City of Portland, Maine - Building or Use Permit Application

Location of Construction: 36 Wyoming Ave	Owner Name: Pines Of Portland Inc	Owner Address: 426 Forest Ave	Phone: 207-772-2127
Business Name: n/a	Contractor Name: Pines of Portland, Inc.	Contractor Address: 426 Forest Ave. Portland	Phone: 2077722127
Lessee/Buyer's Name n/a	Phone: n/a	Permit Type: Single Family	Zone: P-3

BUILDING PERMIT REPORT

**CITY OF PORTLAND, ME
BOCA 1999 Plan Review Record
One and Two Family Dwelling**

4/6/01
 CONCEPTUAL GRADING PLANS LOT 26
 (36 Wyoming Ave) WYOMING
 PLOT PLAN PREPARED BY SEER McCORMACK
 BASED ON GRADING PLAN PREPARED BY
 PINKMAN + GREEN ENGINEERS.

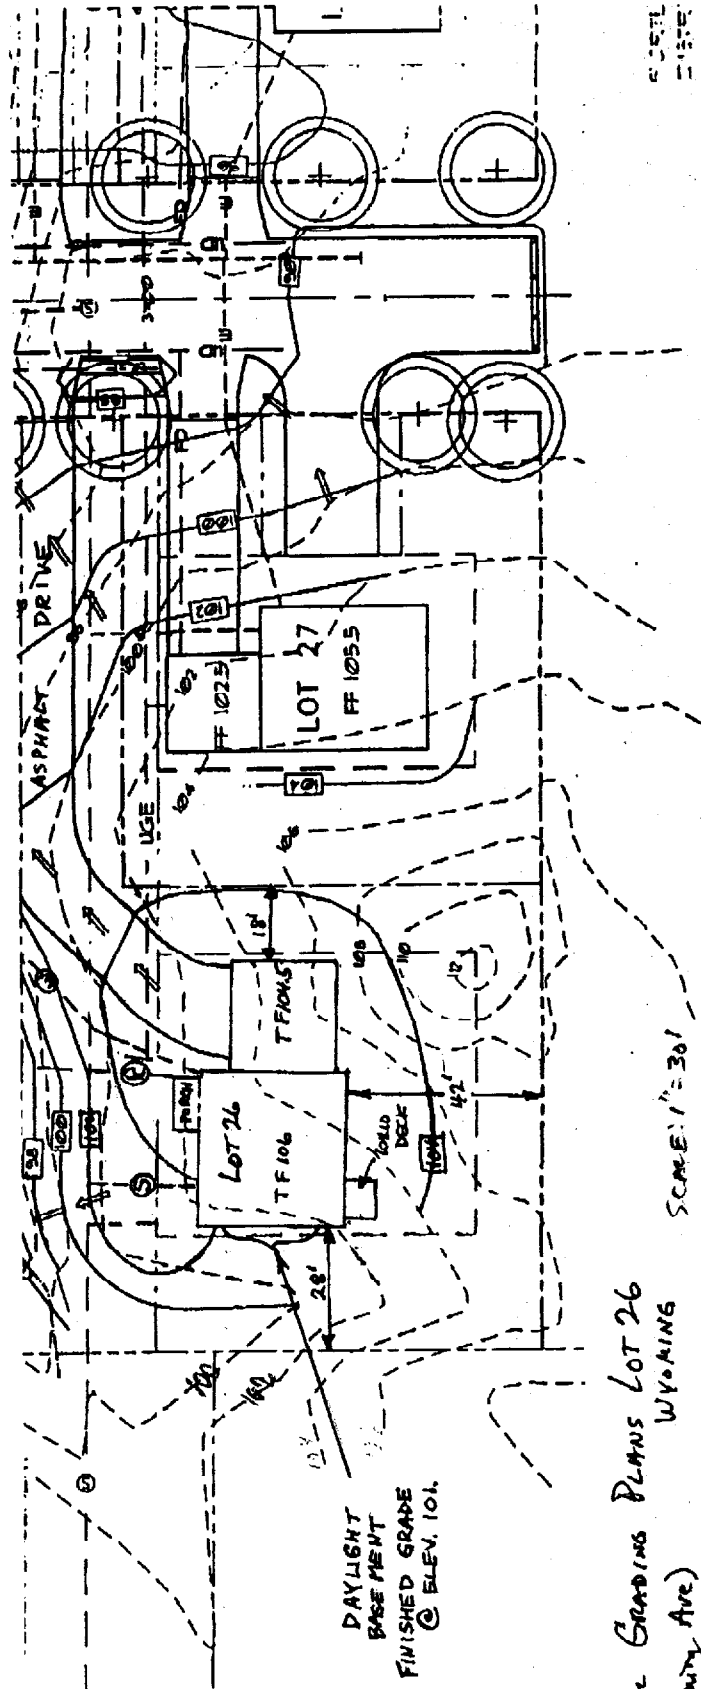
- 1 Prior to Blasting, or issuance of a blasting permit, applicant shall submit to the city's planning dept. The necessary pre-blast information.
- 2 Applicant is to be aware that there is to be "No filling of any area designated as a drainage easement" (note 23 of the recorded subdivision plat). Final grading along the driveway shall conform to this condition.
- 3 All sideslopes that exceed 3 to 1 (33%) shall be rip-rap.
- 4 Applicant will maintain silt fence throughout construction to ensure that the NEARBY WETLANDS are protected at all times.

NOTE: INSTALL RIP RAP/OR OTHER
 PERMANENT SLOPE STABILIZER ALONG
 SLOPES EXCEEDING 3:1
